AX3800S/AX3650S
Software Manual Corrections
(For Version 11.10 and later)

May 14, 2013 (Edition 2)

Changes in Edition 2

Figure 14-17 Operation of suppression functionality for receiving bootstrap messages

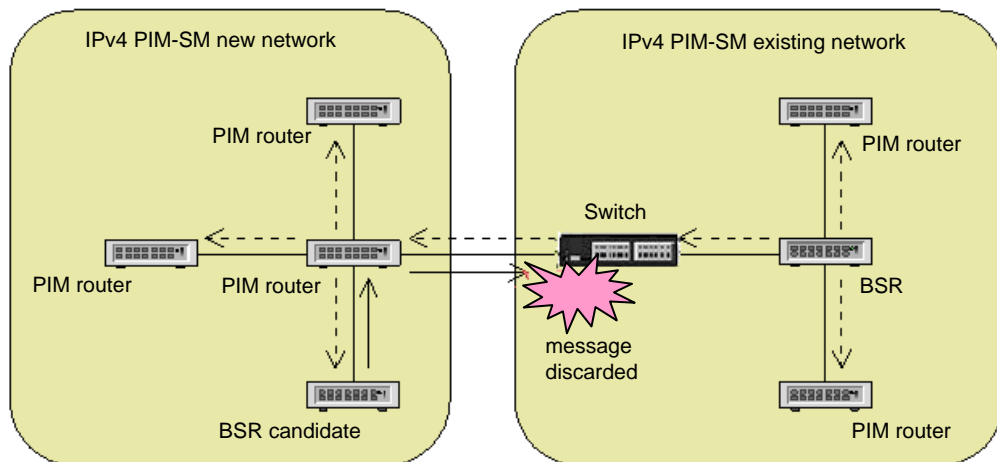
(9) Additional functionality for PIM-SM has been added. [Version 11.11 and later]

When a new network is configured in the multicast network that is in operation and when the BSR candidate is incorrectly set, the BSR candidate becomes the main BSR and might stop the multicast communication in the entire connected multicast network.

This functionality discards the PIM-Bootstrap message that was sent from the newly configured network with an invalid setting, by setting the `ip pim accept-bootstrap` configuration command on the interface that is connected to the new network. This enables protection of the multicast network that is currently in operation. The following figure shows the operation of this functionality.
